TECHNICAL SERVICE BULLETIN

2.7L EcoBoost - Oil Pan Leaking, Original Replacement Pan Not Available

23-2330

This article supersedes TSB 23-2083 to update the Service Procedure and the Part List.

Figure 1

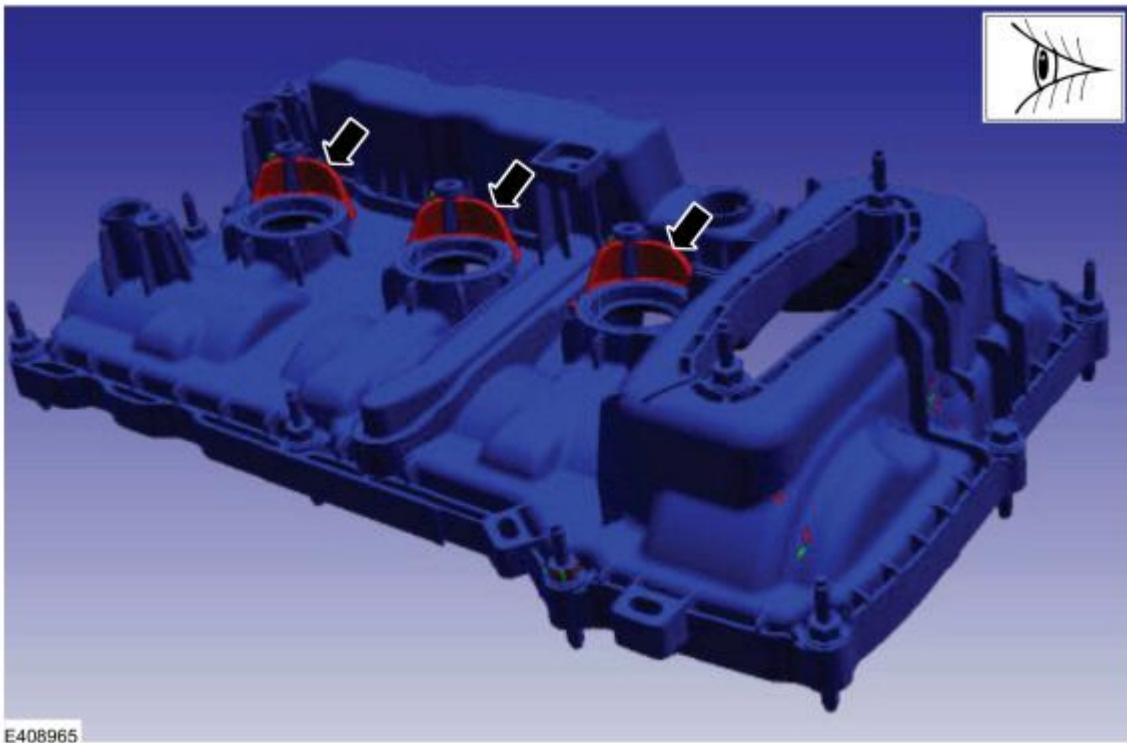
1. Inspect the valve cover design around the ignition coils. Does the coil location have the extended plastic protective ribbing as shown in red? (Figure 1)

(1). Yes - proceed to Step 3.

(2). No - proceed to Step 2.

2. Replace the valve covers. Refer to the procedures in the 2015-2017 F150 Workshop Manual (WSM), Section 303-01A, Removal and Installation > Valve Cover LH and Valve Cover RH.
